DEPARTMENT OF THE NAVY
SOUTHWEST DIVISION
NAVAL FACILITIES ENGINEERING COMMAND
ENVIRONMENTAL DIVISION
1220 PACIFIC HIGHWAY, RM 18
SAN DIEGO, CALIFORNIA 92132-5181

M60050.000935
MCAS EL TORO
SSIC # 5090.3

5090
Ser 09E/641
April 27, 1995

Total Dissolved Solids (TDS) Increase Impacts to Water Usage

- FEATURES:**
- BEDROCK
 - LAKE OR RESERVOIR
 - FREEWAY
 - ROAD
 - MCAS EL TORO BOUNDARY
 - WASH OR STREAM
 - TCE CONTOURS
 - DESALTER WELL

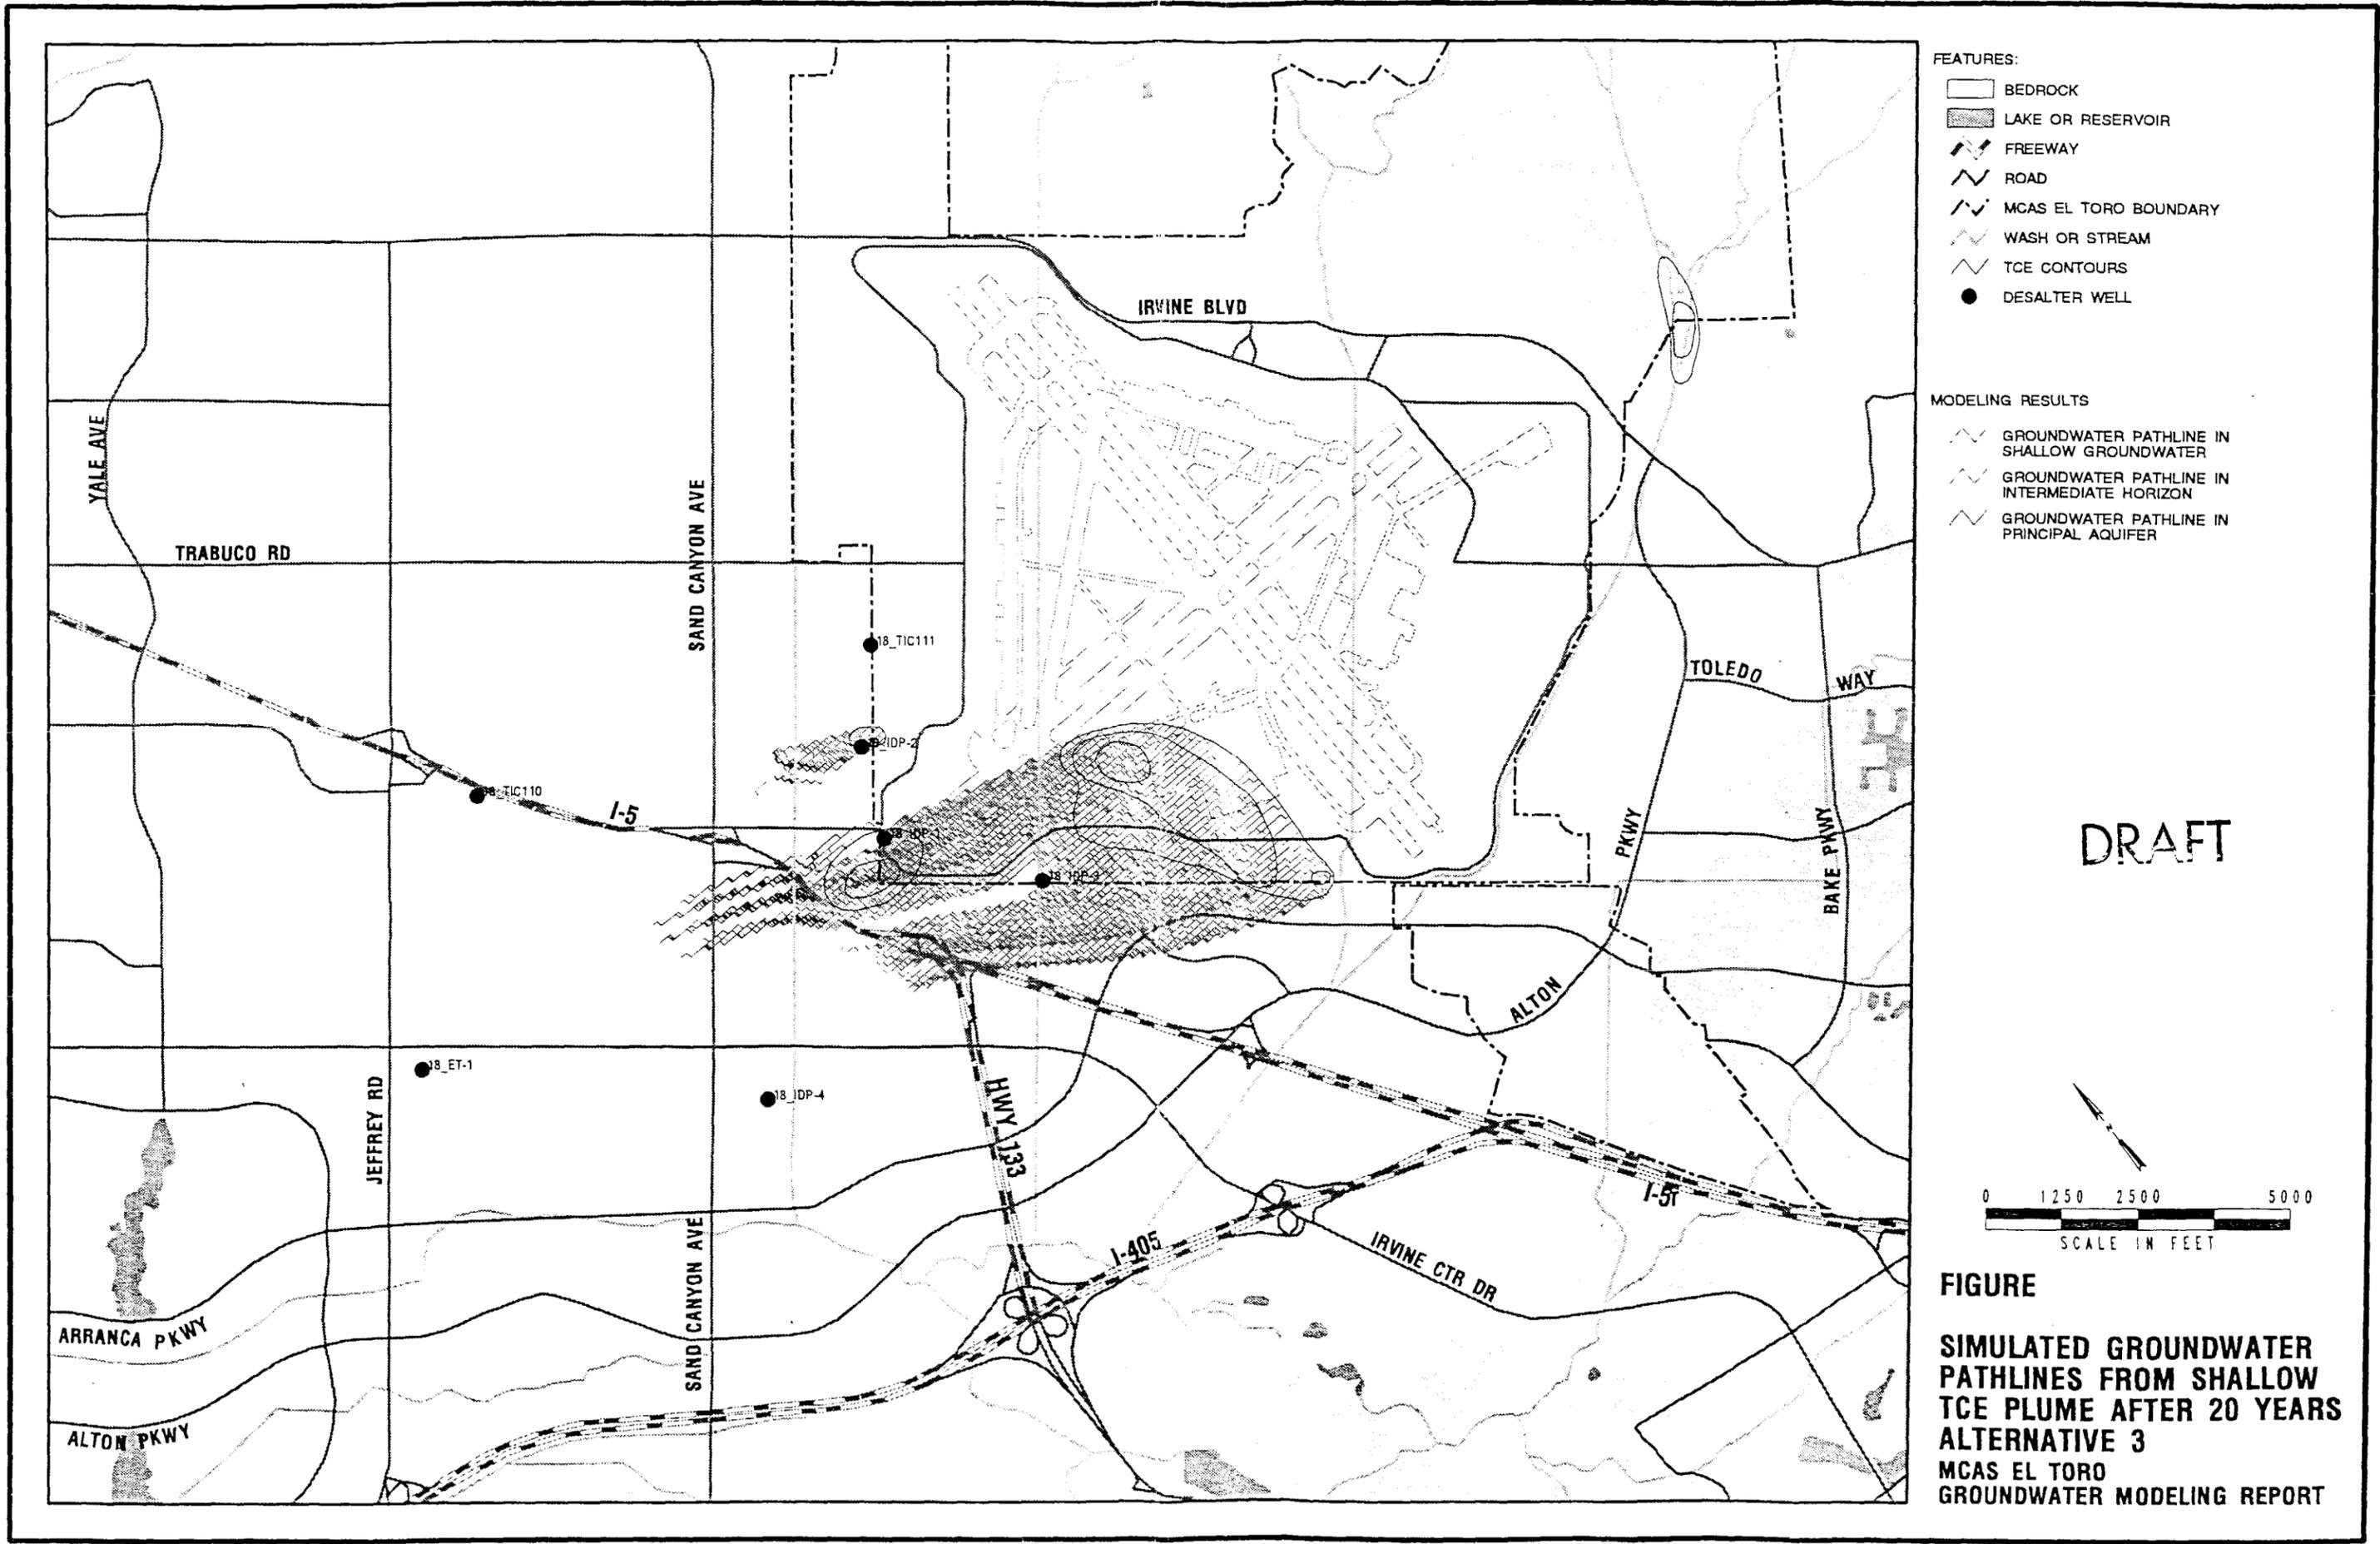
At the April 13 meeting, 20 year simulated TCE plume groundwater pathlines for the shallow groundwater (enclosure 1) and principal aquifer (enclosure 2) were presented. Both sets of figures model Alternative #1 (No Action), Alternative #2 (Independent DON stand-alone system), and Alternative #3 (Irvine Desalter Project). Although the simulations are for TCE particle tracking, TDS particle tracking would be similar. Even though both Alternative #2 and #3 are improvements over the No-Action scenario, the modeling clearly indicates that Alternative #2 controls particle migration much better than

Alternative #3. This comparison is most evident near the southwest boundary of the Marine Corps Air Station (MCAS) El Toro where Alternative #3 allows significant migration of low quality shallow groundwater into the principal aquifer; refer to enclosure (1).
